**Re: LC 73 PGE IRP Update Comments**

NewSun Energy LLC (NewSun) provides these comments on Portland General Electric's (PGE's) Integrated Resource Plan (IRP) Update filed on January 29, 2021.

**PORTLAND GENERAL ELECTRIC**  
**LC 73**  
**PGE Response to REC Data Request No. 025**  
**Dated February 22, 2021**

**PORTLAND GENERAL ELECTRIC**  
**LC 73**  
**PGE Response to REC Data Request No. 026**  
**Dated February 22, 2021**

**Figure 1. Solar ELCC Comparison**

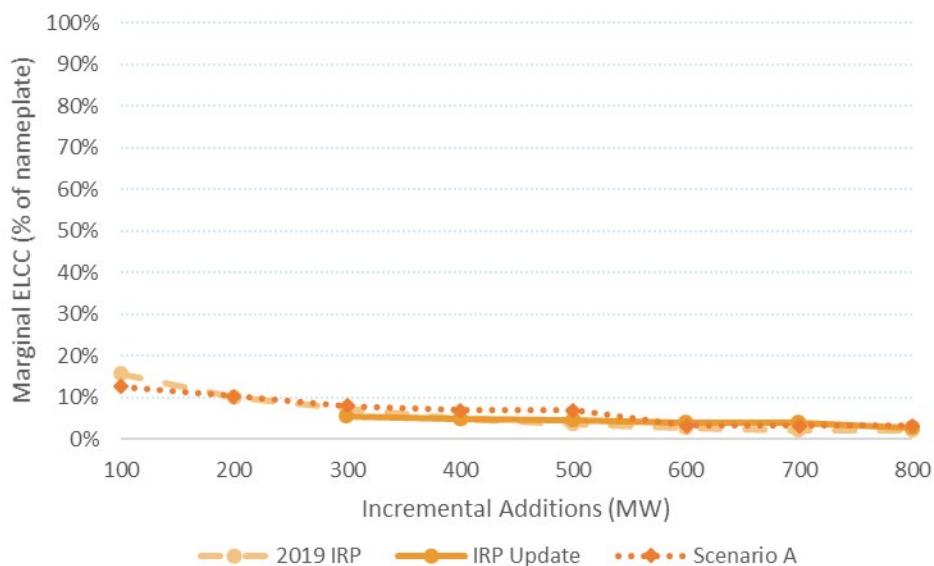
In order to provide some additional insight into the impact of the additional solar resources in the Baseline Portfolio, PGE prepared analysis examining a scenario based on the 2019 IRP Update Sequoia model with 200 MW of solar resources removed from the Baseline Portfolio to approximate the quantity of solar in the 2019 IRP study. **Figure 1** compares the ELCC values for solar from the 2019 IRP and the IRP Update with the scenario (labeled Scenario A in the figure).<sup>4</sup> The figure aligns the ELCC values based on the approximate quantity of solar resources in each study. The scenario showed a similar pattern to the 2019 IRP, with a higher initial ELCC value for solar than the IRP Update (as expected due to a reduction of solar in the portfolio compared to the IRP Update), and a declining value for the next increments. There was little change to the ELCC values for Gorge Wind and the SCCT compared to the IRP Update (26% and 95.2% in Scenario A compared to 25% and 95.5% in the IRP Update).

As discussed previously, the capacity need reporting convention in the IRP Update (and Scenario A in Figure 1) differs from the 2019 IRP. It is important to note that when converting capacity contribution MW values to \$/kW-yr values, the net cost of capacity should be based on the same reporting convention as the ELCC values.
